# Access Compliance Report

## Public Rights-of-Way

### (Curb Ramps)

Intersection ID: 10034320	Main Street: PERIMETER_PY	Cross Street: N/A	Location: W
ADA ID: FAB1ED0D624D	Ramp Type: Perp	Initial Pass/Fail: Fail	Overall Compliance: No
Severity Score: 10			
Codes/Mitigation Info/Possible Solution		Field Measurements/Component Compliance

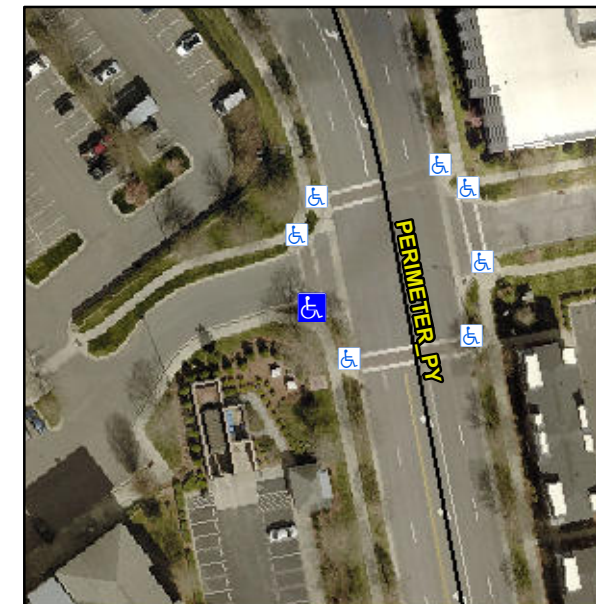
**Not Found, R304.5.1, R304.5.3**

Compliance	Description	Data	Compliance	Description	Data
N/A	Ramp Length (in)	56.0	Yes	Ramp Slope (%)	6.1
No	Ramp Width (in)	47.5	No	Ramp XSlope (%)	4.2
N/A	Flare Type LT	N/A	N/A	Flare Type RT	N/A
N/A	Flare Slope LT (%)	N/A	N/A	Flare Slope RT (%)	N/A
N/A	Flare Traversable LT?	N/A	N/A	Flare Traversable RT?	N/A
N/A	Landing Length (in)	N/A	N/A	DWS Provided?	N/A
N/A	Landing Width (in)	N/A	N/A	DWS Contrast?	N/A
N/A	Landing Slope (%)	N/A	N/A	DWS Length (in)	N/A
N/A	Landing X Slope (%)	N/A	N/A	DWS Full Width?	N/A
N/A	Landing Curb? (Y/N)	N/A	N/A	DWS Offset (in)	N/A
N/A	Shared Landing?	N/A			
N/A	Gutter Ponding?	N/A	N/A	Gutter Slope (%)	N/A
N/A	Gutter Lip Ht (in)	N/A	N/A	Gutter X Slope (%)	N/A
N/A	Painted X Walk1?	Yes	N/A	Painted X Walk2?	N/A
	X Walk 1 Direction	To NE		X Walk 2 Direction	N/A
N/A	X Walk 1 Width (in)	72.0	N/A	X Walk 2 Width (in)	N/A
	X Walk 1 Slope (%)	3.3		X Walk 2 Slope (%)	N/A
	X Walk 1 X Slope (%)	1.8		X Walk 2 X Slope (%)	N/A

**Remove & Replace Entire Ramp.**
